City of Bristol
Zoning Commission

REGULAR MEETING - MONDAY, JANUARY 13, 2025
CITY HALL COUNCIL CHAMBERS
111 NORTH MAIN STREET
6:00 P.M.

- a. Application #2512 – Special Permit for a Unified Residential Development (15 units) at Earl Street, east of Crown Street and west of Melrose Street; Assessor's Map 14, Lots 72-71, 73-70, 74-69, 75-68 & 76-67 Earl Street; R-15/RM (Single Family Residential/Mixed Residential Overlay) zone; DGG Development, LLC, applicant.

- b. Application #2513 – Site Plan for a Unified Residential Development (15 units) at Earl Street, east of Crown Street and west of Melrose Street; Assessor's Map 14, Lots 72-71, 73-70, 74-69, 75-68 & 76-67 Earl Street; R-15/RM (Single Family Residential/Mixed Residential Overlay) zone; DGG Development, LLC, applicant.

ASSESSOR'S MAP/LOT:	14/72/71, 14/73/70, 14/74/69, 14/75/68 & 14/76/67	DRAWING NO.	PLN-001
DRAWING TITLE:	LAYOUT, SIGNS AND PAVEMENT MARKINGS PLAN	SHEET NO.	5

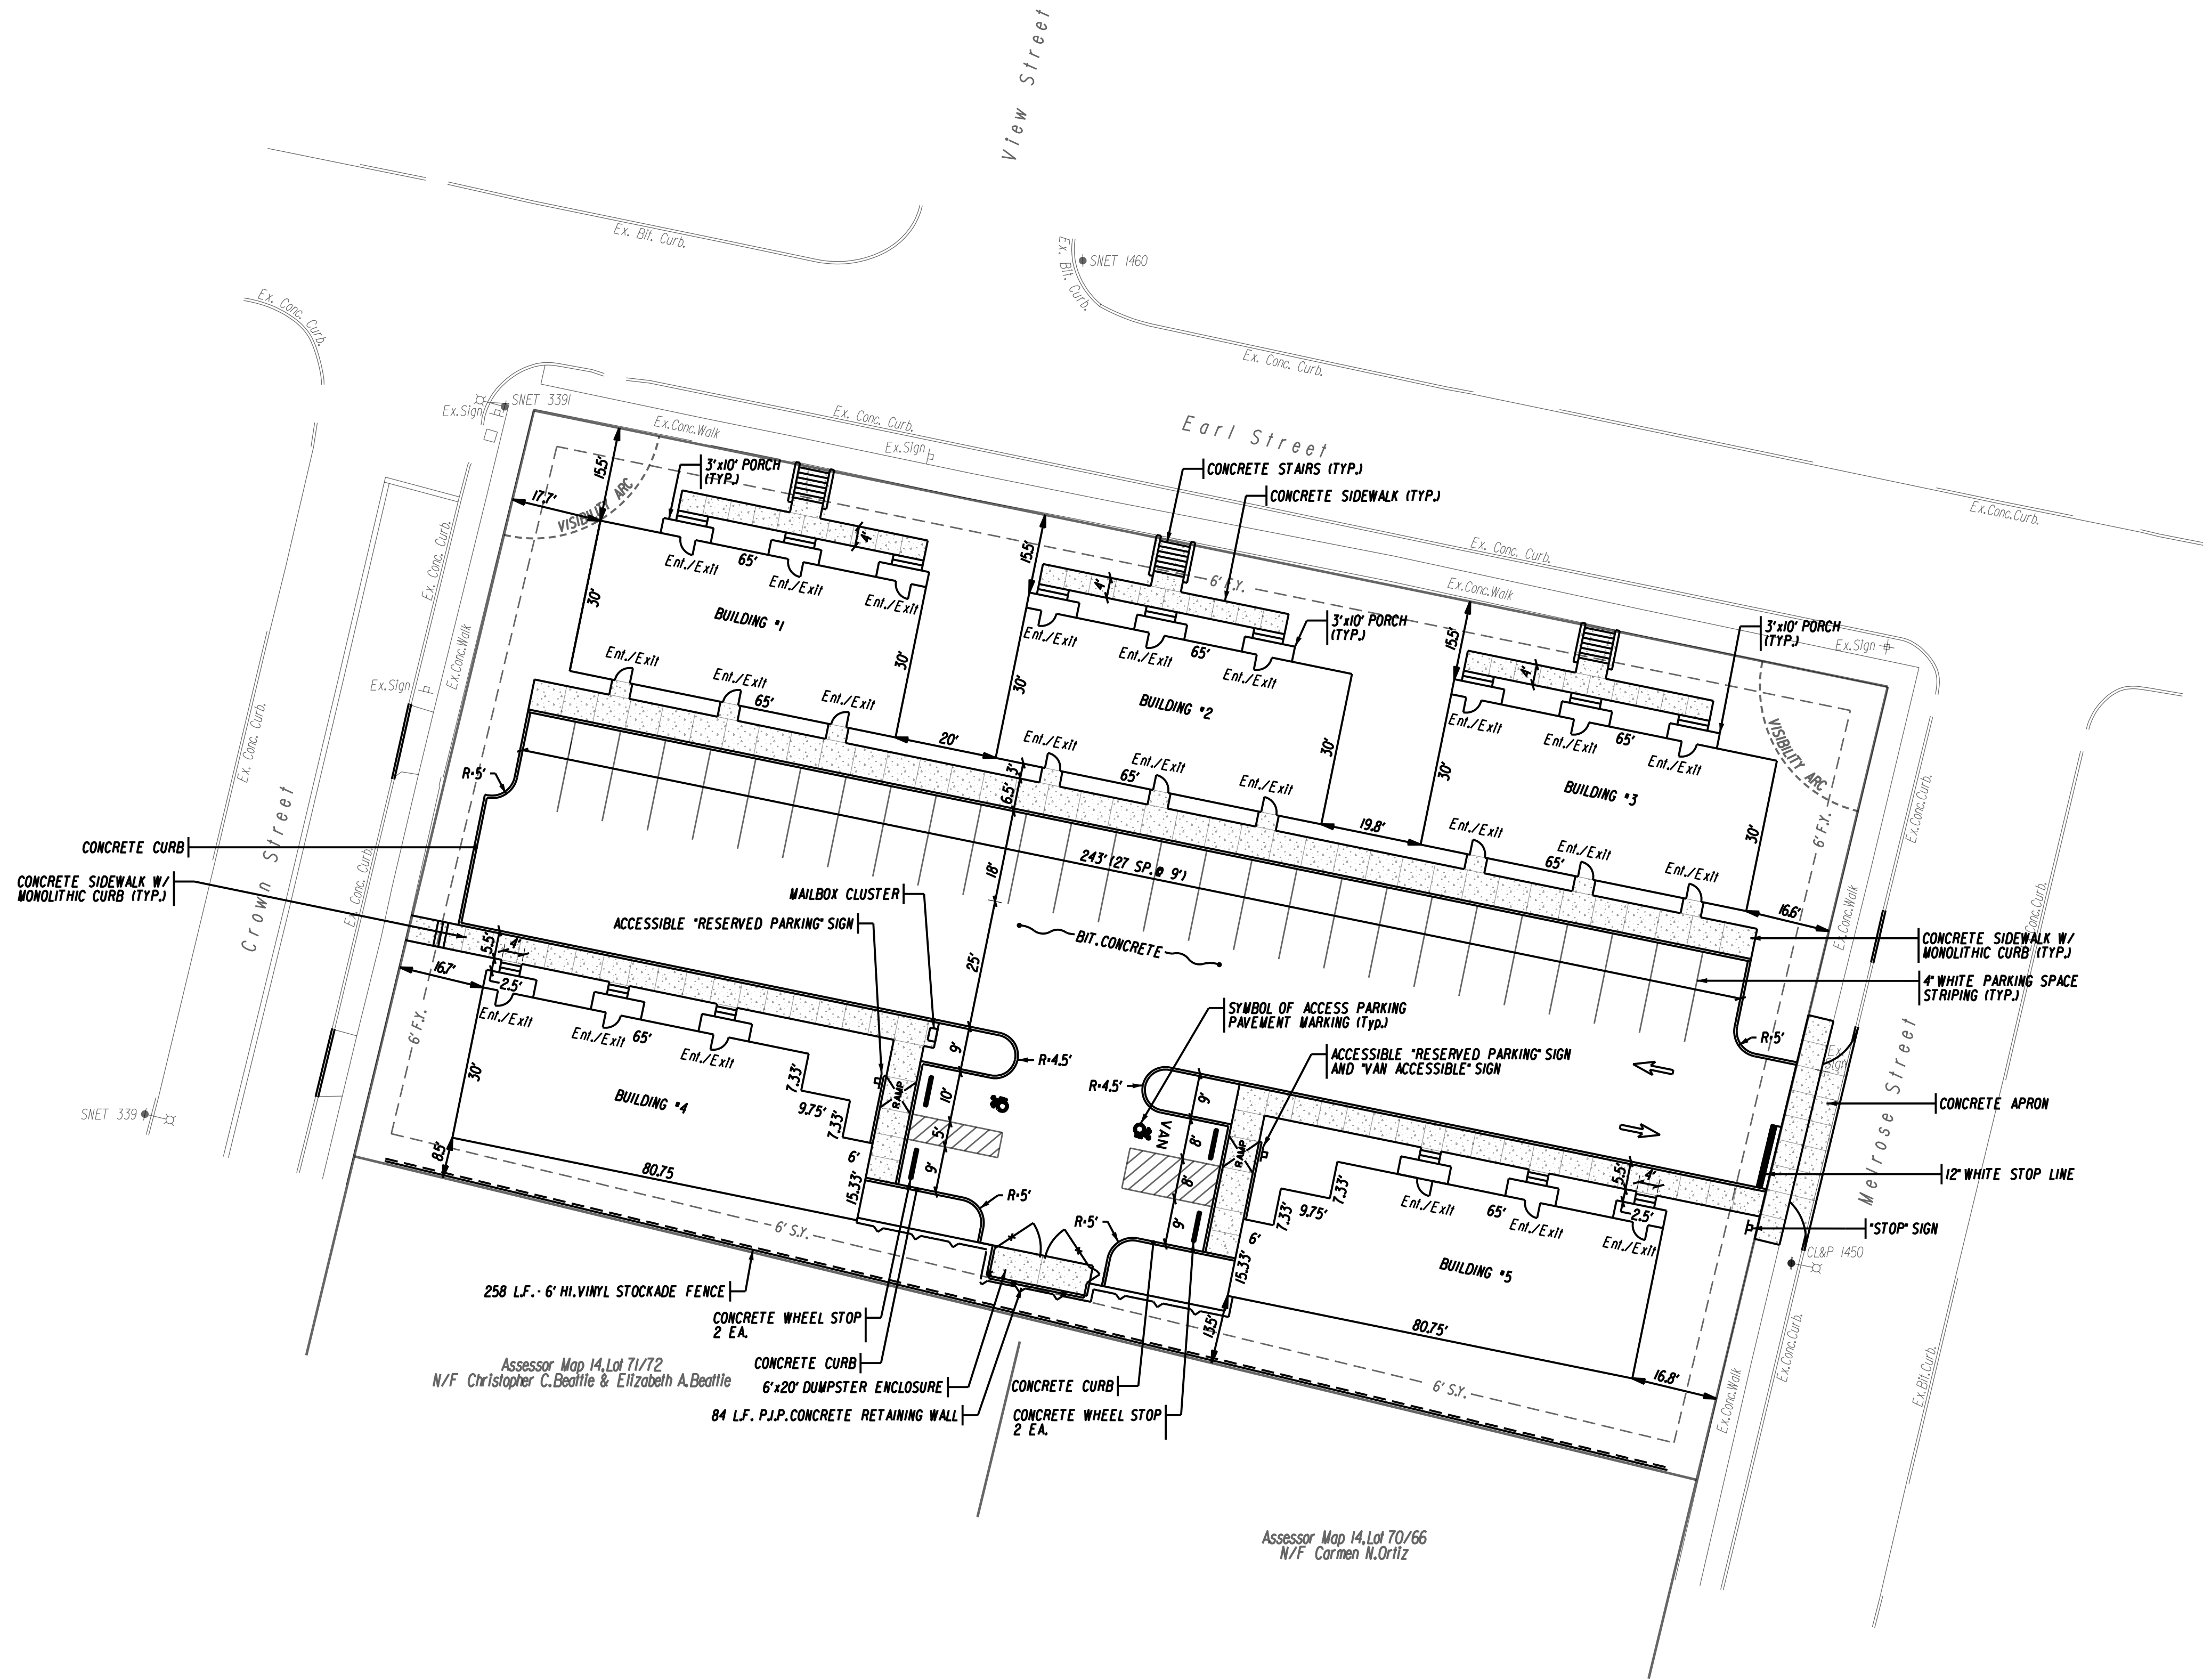
16. On sheet 5 the ramp locations are shown as blocked by the wheel stop's, the ramps should be placed in the hatched area.

9/6/24 City Response: Show ramp on site plan. Curb appears to still be shown across both ramp accessways on “Sheet 5”. The detail sheets referenced were not included with the revised plan set.

12/11/24 City Response: Comment remains. Revise plan on Sheet 5.

11/6/24 Applicant Response: Wheel stops prevent vehicle overhang onto ramp. See accessible parking site detail, sheet 11.

12/30/24 Applicant Response: The concrete sidewalk is flush adjacent to the standard parking space and crosshatched area with the ramp running along and in front of the handicapped space. The individual will exit the parked vehicle onto the hatched area, enter the flush sidewalk and proceed North up the ramp to the standard sidewalk. This isometric detail on Sheet 11 depicts the design and expected construction, with spot elevations on the grading plan providing top and bottom of curb elevations, identifying flush curb and curb with reveal. The wheel stops are to prevent vehicle overhang onto the ramp.

12/30/24 Applicant Response: The concrete sidewalk is flush adjacent to the standard parking space and crosshatched area with the ramp running along and in front of the handicapped space. The individual will exit the parked vehicle onto the hatched area, enter the flush sidewalk and proceed North up the ramp to the standard sidewalk. This isometric detail on Sheet 11 depicts the design and expected construction, with spot elevations on the grading plan providing top and bottom of curb elevations, identifying flush curb and curb with reveal. The wheel stops are to prevent vehicle overhang onto the ramp.

ASSESSOR'S MAP/LOT:	14/72/71, 14/73/70, 14/74/69, 14/75/68 & 14/76/67	DRAWING NO.	UTIL-001
DRAWING TITLE:	DRAINAGE AND UTILITIES PLAN	SHEET NO.	6

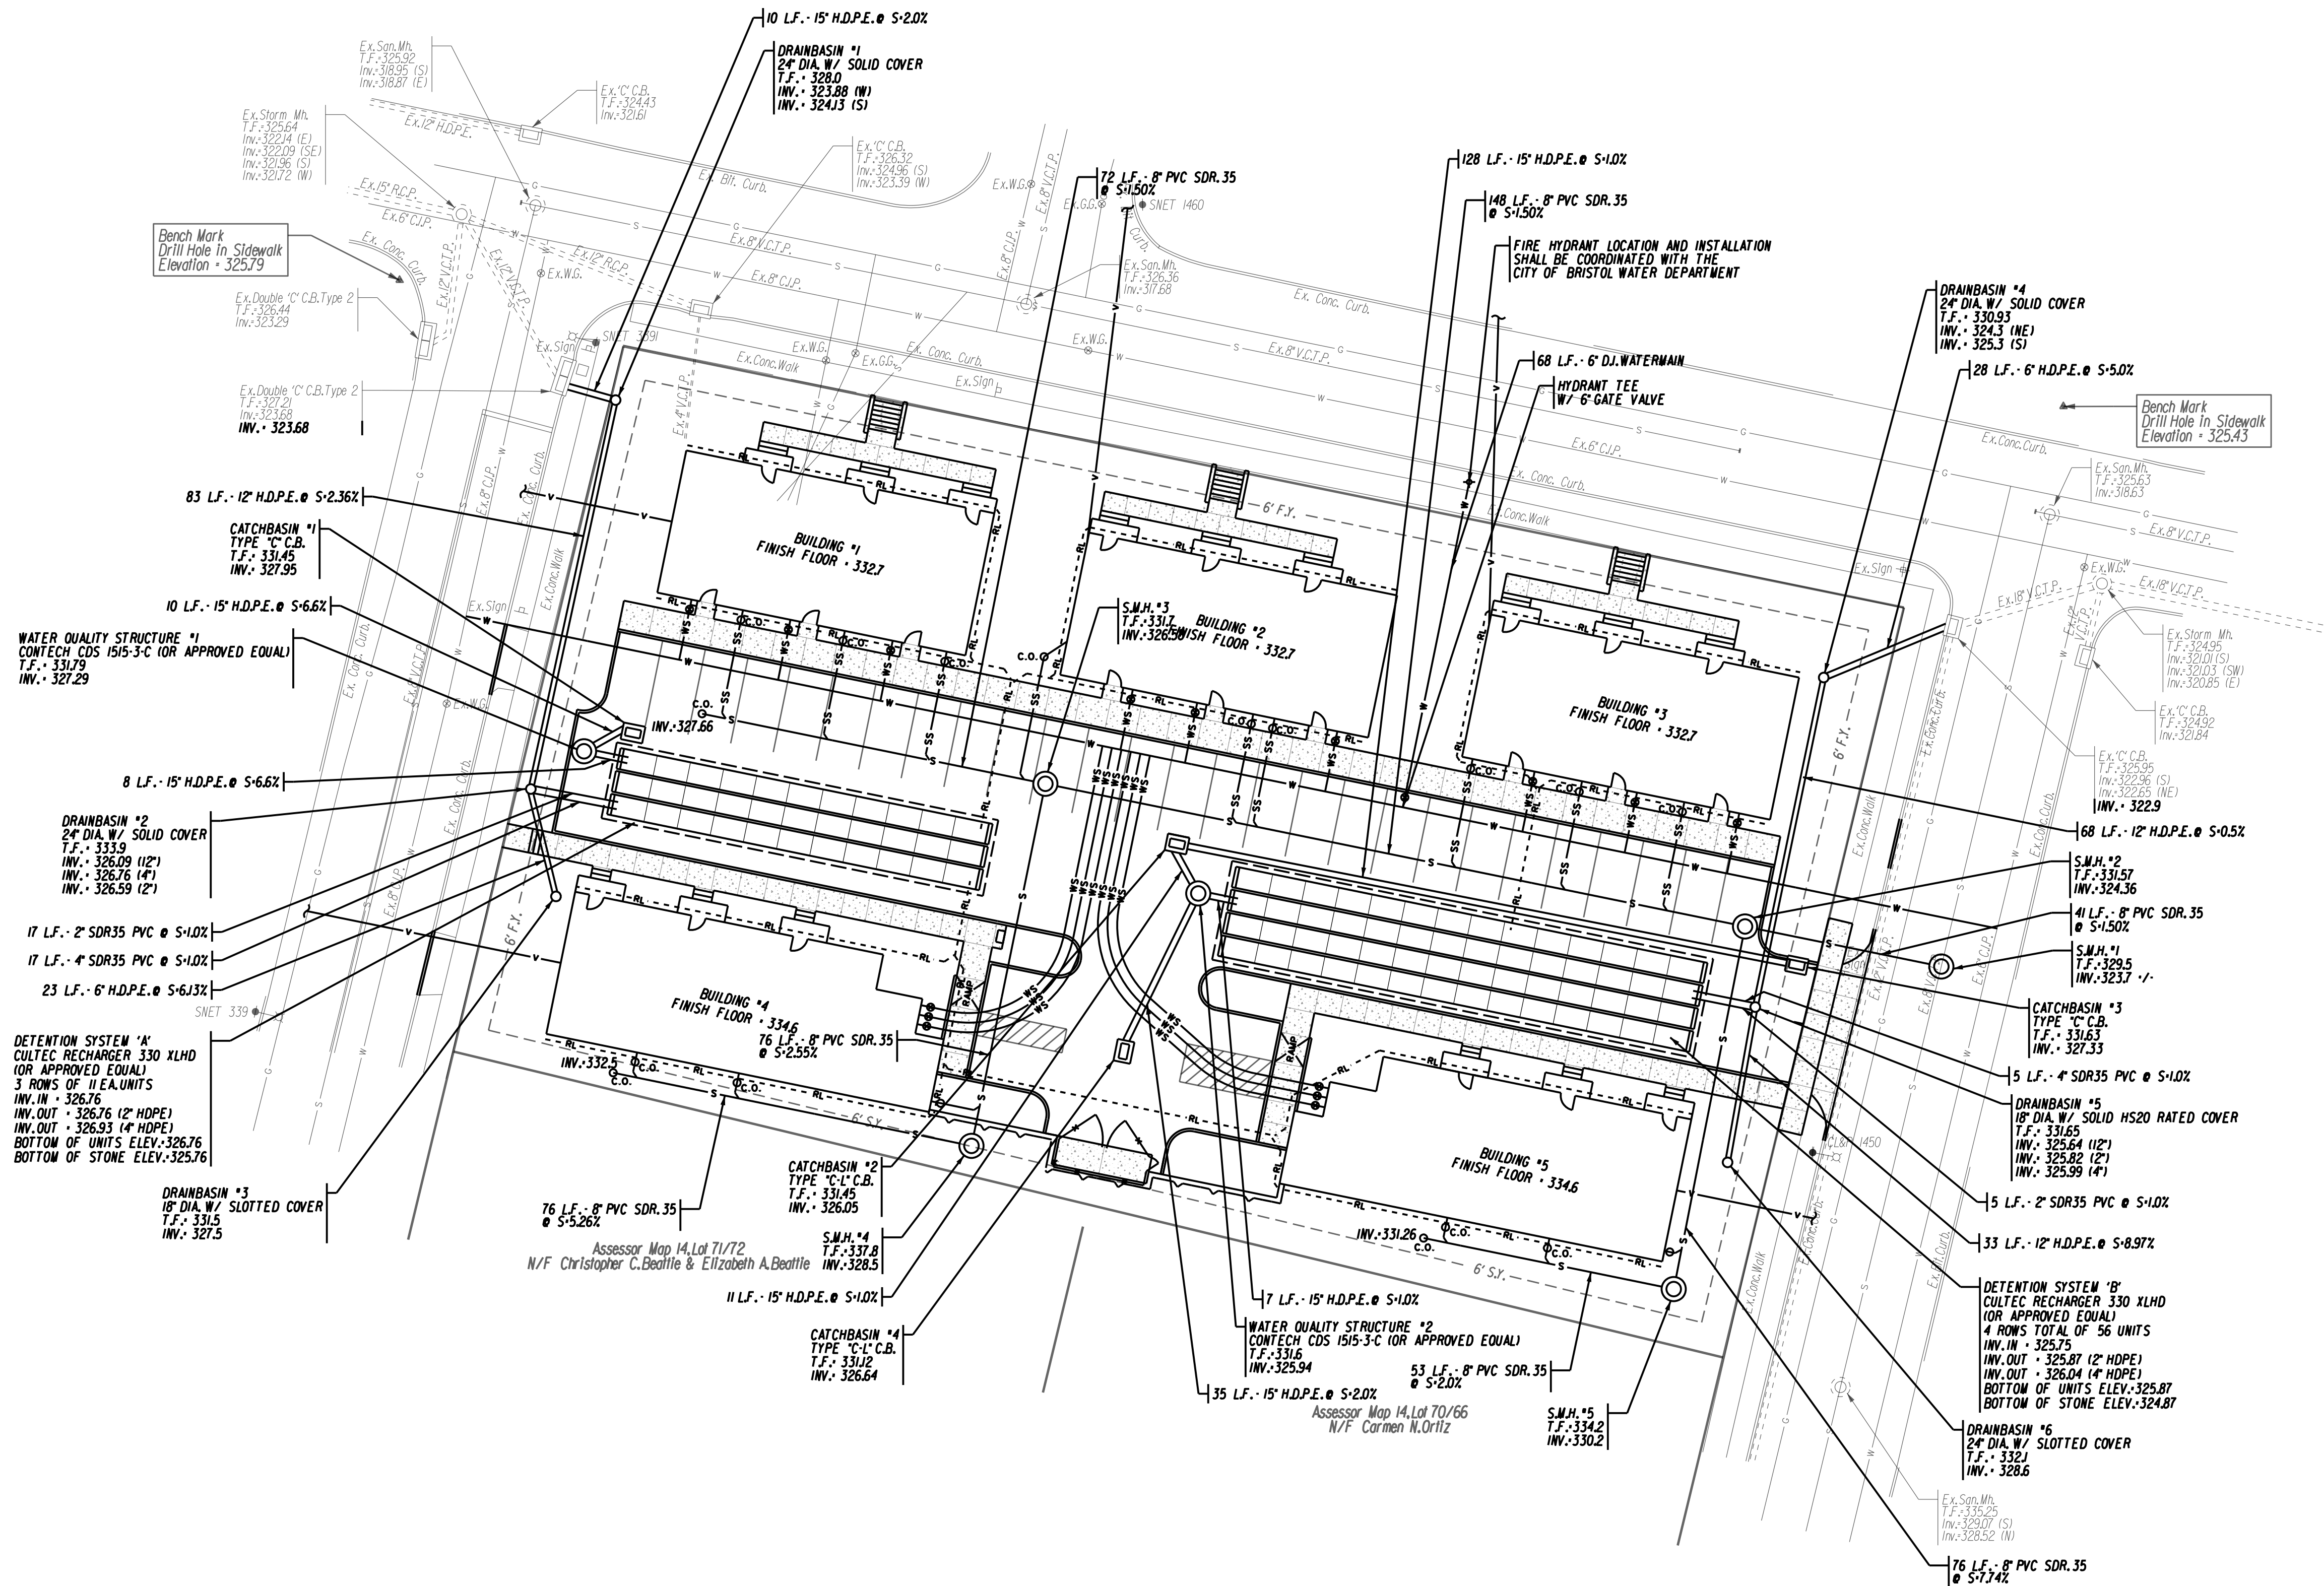
9/6/24 Updated City Response: *Partially addressed, need updated sheet 6.*

20. A revised drainage plan sheet 6 and drainage report have not been attached for review.

11/6/24 Applicant Response: See attached revised sheet 6 Drainage and Utilities Plan.

11/6/24 Applicant Response: See attached revised sheet 6 Drainage and Utilities Plan.

11/6/24 Applicant Response: Done. See attached revised sheet 6 Drainage and Utilities Plan and drainage report.
